Discovery Water Ingress Manual

CIRCULATE TO:-		TECHNICAL INFORMATION		LAND-ROVER
SERVICE MGR.	<input checked="" type="checkbox"/>	SUBJECT 'E' Post Trim Area - Water Ingress		issue 2
RECEPTION	<input checked="" type="checkbox"/>			
WORKSHOP	<input checked="" type="checkbox"/>			
PARTS	<input checked="" type="checkbox"/>			
MODEL Discovery		AFFECTED VEHICLES LP LH LJ 081991 onward LD		
<p>DETAIL</p> <p>Investigations have shown that on some vehicles water can enter into the vehicle around the 'E' post, there can be several causes for water ingress in this area, all known water ingress paths and fixes are detailed on the flow chart attached.</p> <p>ACTION REQUIRED Upon customer complaint of water ingress around the 'E' post, follow the flow chart overleaf.</p>				
<p>PARTS INFORMATION</p> <p>Not applicable</p>		<p>ILLUSTRATION</p> 		
<p>PROCEDURE</p> <p>See flow chart overleaf</p>		<p>WARRANTY Normal warranty policy and procedures apply</p> <div style="border: 1px solid black; padding: 5px; margin-top: 20px;"> <p style="text-align: right; margin: 0;">COMP. CODE</p> <p style="text-align: right; margin: 0;">9L4N</p> </div> <p>SRO 76.11.89/31 Attend 'E' post water ingress on vehicles wi

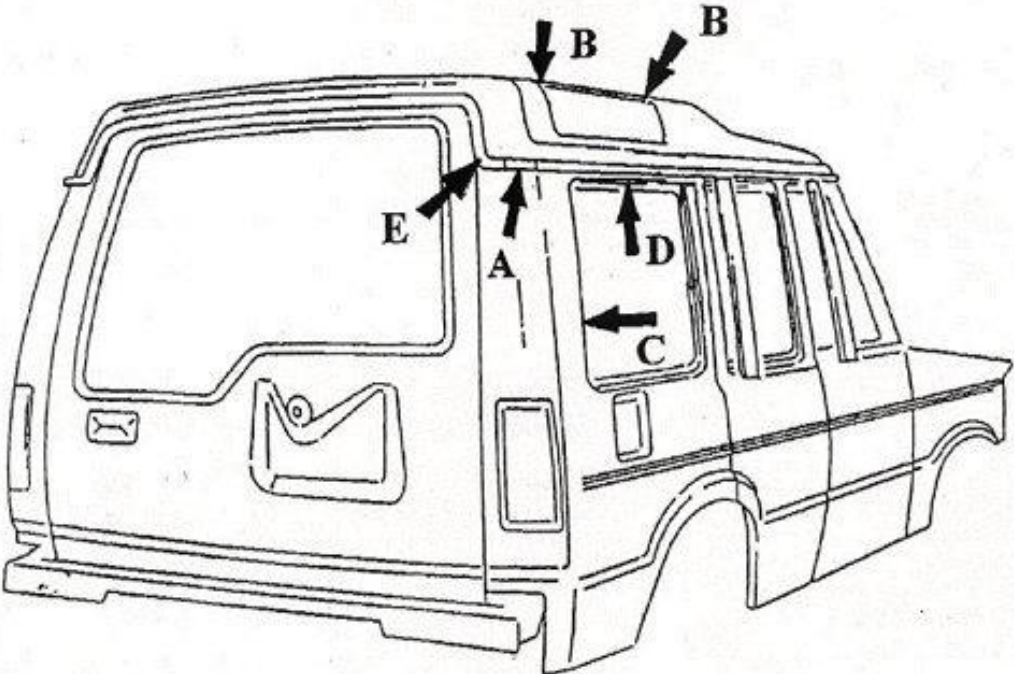
Water drips from alpine light
(see illustration, arrow B)

Check fixed glass sealing and reseal as
necessary (see illustration arrow C)

Check for cracks around flange see 'E' on
illustration, reseal each side of flange.
The flange has been moved inside can't
rail to improve water ingress concerns from
Vins 199607 and 530346

Reseal alpine light glass to rubber and rubber to
body on outside surface

ILLUSTRATION

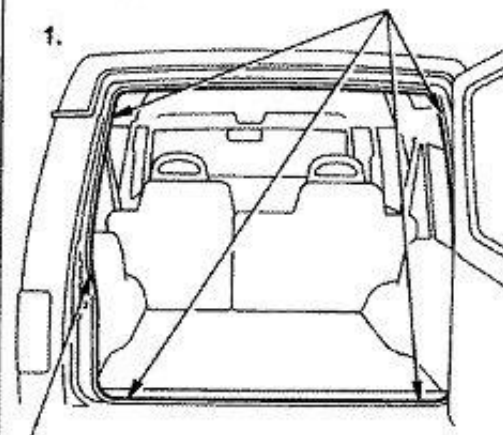
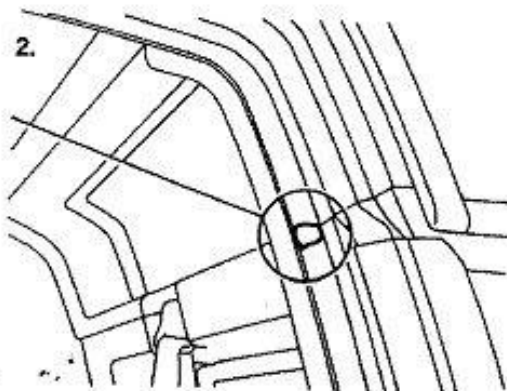
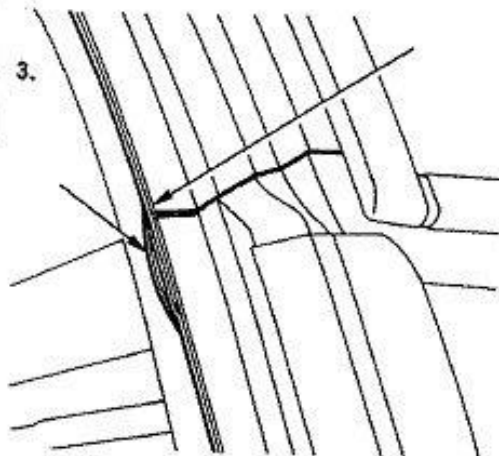
As part of ongoing quality improvements a new double bubble seal has been introduced onto the rear tail door. Early indications have identified a potential water leak from this area due to seals fitting incorrectly on a misformed seal flange. Investigations by Land Rover engineers have found that following procedure overcomes this issue on all vehicles.

1. Remove rear end door tread strip.
2. Remove rear end door seal from failed vehicle.
3. Using a craft knife, cut any excess trim tape that has been wrapped around the rear end door aperture see illustration 3.
4. Dress any flanges that appear to have panel mismatch to obtain a tight finish see illustration 1&2.
5. Smooth in Butyl around the four areas where the panel meets and form a channel to obtain a smooth finish for the foam tape see illustration 1&2.
6. Carefully apply the foam tape around the aperture as close as possible to the edge of the panel. Remove backing paper, smooth out, avoid any creases see illustration 1.

7. Working in an anti-clockwise direction feed the door seal on by hand, the joint of the door seal must be in the centre of the door aperture at the bottom. Ensure all the corners are of a tightfit and the foam and the trim tape have not been disturbed or snagged. Hammer the door seal onto the aperture tightly.

ILLUSTRATION

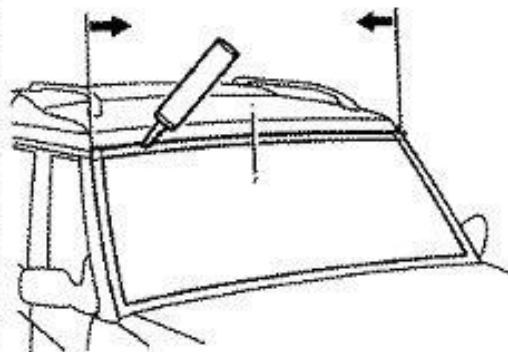
To overcome water ingress through the upper section of the windscreen seal a process has been developed to introduce a supplementary sealing operation behind the seal. Should a vehicle exhibit water ingress from this area follow the procedure below.

Peel back the windscreen rubber at the top for access.
Thoroughly clean area to be sealed using cleaner provided.
Locate sealant nozzle between top windscreen rubber and roof panel, extrude bead of sealant (continuous) from the centre of the vehicle towards the corners (see illustration opposite).
Finish sealing in the corner.
Clean off any excess sealant from the windscreen/ rubber and paint.

Care point: angle the sealant away from the painted panel.

MODIFIED GUIDE TUBE (ILLUSTRATION A)

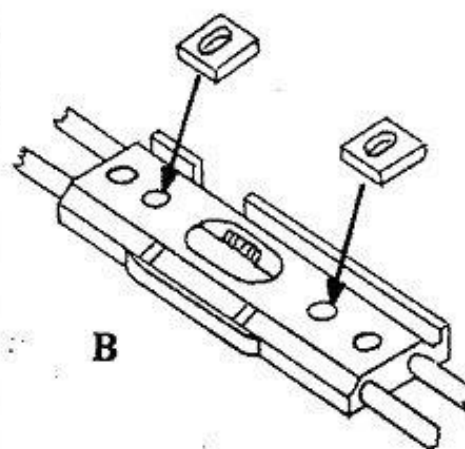
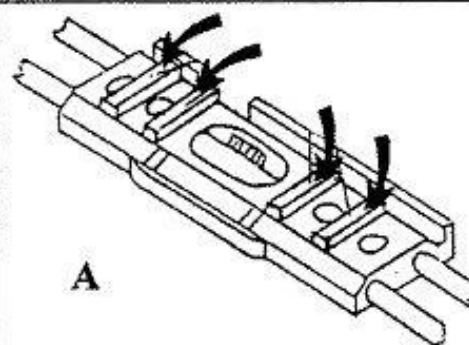
Following recent improvements to the sunroof lower tray STC 1686 and the guide tube assembly STC 1683, a spacer kit Part No STC 3194 (containing 4 white spacers) will be required if either the sunroof lower tray or the guide tube assembly are changed in vehicles prior to the Vins given.

When fitting a modified lower tray to an unmodified guide tube x 2 spacers must be fitted to the guide tube.

Gently lift the guide tube assembly off the two locating pegs on the upper frame to gain enough clearance to insert the spacers over the two inboard holes as indicated then reseal the guide tube assembly.

MODIFIED LOWER TRAY ILLUSTRATION 'C'

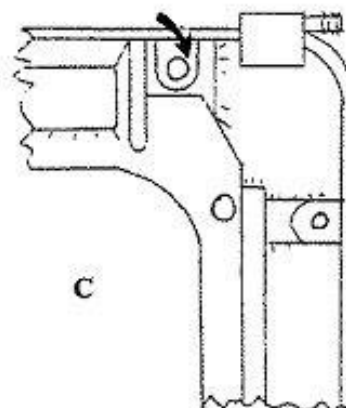
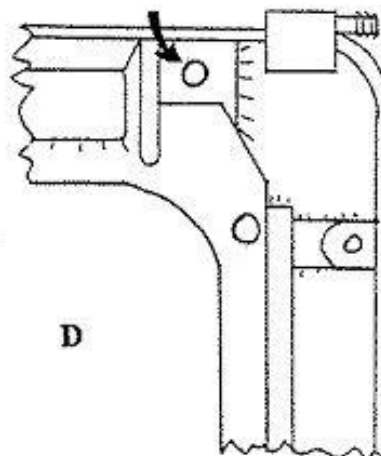
Underside view look for 'U' shaped impression around corner hole as shown opposite.

Underside view no impression around hole as shown opposite.

Fit x 4 spacers as indicated opposite to the inside of the lower tray.

When fitting a modified guide tube assembly to an unmodified lower tray x 4 spacers must be fitted to the inside of the lower tray as indicated opposite.
